stm32-blinky — Design Document

Board review: stm32-blinky (P8 adversarial pass)

Reviewer: verify-reviewer (fresh context). Machine gate state re-verified independently: verify_all re-run from scratch on the current board = PASS, all 8 checks 0 violations (return_path, current, decoupling, diffpair, creepage, thermal, silk, pdn). DRC routed 0/0. What follows is what the scripts cannot see.

reports/renderers/stm32-blinky_top.png

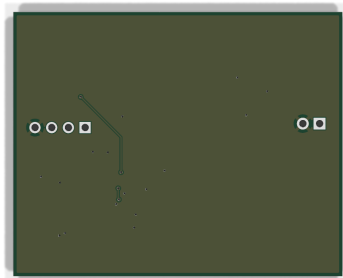
ERROR 1 - J1 power input has no polarity legend on silk (requirements miss)

requirements.md sec 2 and architecture/blocks.md both promise the 5 V input "polarity marked on silkscreen" (J1 pin 1 = +5 V, pin 2 = GND). The as-built board has NO text or +/- legend anywhere: silk carries refdes only (there is not a single gr_text on the board). What exists at J1 is a pin-1 dot and a square pad (see crop-j1_d1.png) - and the dot sits on the header body outline,

so after the header is soldered the plastic covers it. Post assembly the top side shows nothing but "J1"; the square pad is visible only from the bottom.

Consequence: the unkeyed 2-pin input can be plugged backwards with no on-board hint. D1 (series SS34) prevents damage - reversed input just does not conduct - but the user gets a dead board and no way to know why or which way is right without opening the design files. This is the board's primary human interface and an explicit requirements promise. Fix is two silk texts ("5V", "GND" or "+", "-") next to the holes, outside the header body. Must fix before fab; there is ample empty silk area (left region is empty).

WARNING 1 - J2 SWD pins unlabeled (architecture promise miss)

`blocks.md` promises "Canonical pin order (silk-labeled): 1 = SWDIO, 2 = SWCLK, 3 = 3V3, 4 = GND". Electrical order verified correct from the netlist (pads: SWDIO/SWCLK/+3V3/GND, U1 PA13/PA14 to pins 1/2). But there are no labels - only a pin-1 square cell (`crop_d2_j2.png`) which the header body covers after assembly. ST-Link clones are wired pin-by-pin; swapping 3V3/GND shorts the debugger's 3.3 V rail to ground. Same trivial fix as ERROR 1 (four small silk texts below the header row - the area under J2 is clear). Strongly recommend fixing together with ERROR 1; warning rather than error only because `requirements.md` itself demands the ORDER (met), the labels are an architecture-level promise.

WARNING 2 - refdes association ambiguity (cap cluster + C3-under-J2)

- "C11" text sits directly above R1's body; "C1" text below-left of R1; "C7"/"C8" labels float between parts they do not touch. Among these 0603s are four DIFFERENT cap values (22 pF, 10 nF, 100 nF, 1 uF) plus a 1 k resistor - a hand-rework or debug probe guided by silk has a real chance of landing on the wrong part.
- "C3" text renders directly under J2 pads 3-4 and reads like a header label (its own body is 3.6 mm away). Mildly reinforces the J2 labeling problem: someone may read "C3" while counting SWD pins.

Assembly itself is CPL-driven, so production risk is nil; consequence is limited to bench rework/debug confusion. WAIVER RECOMMENDED for rev A - but since ERROR 1 forces a silk edit session anyway, nudging these labels onto their parts at the same time costs minutes.

NOT waivable in this reviewer's judgment: ERROR 1 (J1 polarity legend) - explicit requirements promise, primary user interface, zero-cost fix.
